**3** x 95.002-26

## Model 250R/RX

## New flywheel

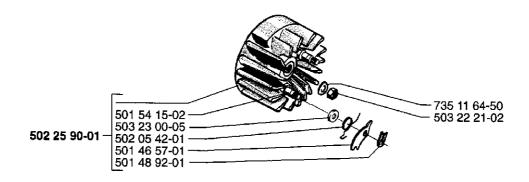
A new improved flywheel with a cast key has been introduced. Due to this a new crankshaft with two keyways, transposed 180° in relation to one another, was introduced some time ago. One keyway for the flywheel with the cast key and one for a separate keyway. This means that flywheels with and without the cast key can be fitted to the crankshaft with two keyways. Older crankshafts with one keyway can only accommodate flywheels intended for use with separate keyways, (503 03 35-05).

Introduced from serial number: 250R 503 0115 250RX 507 0180
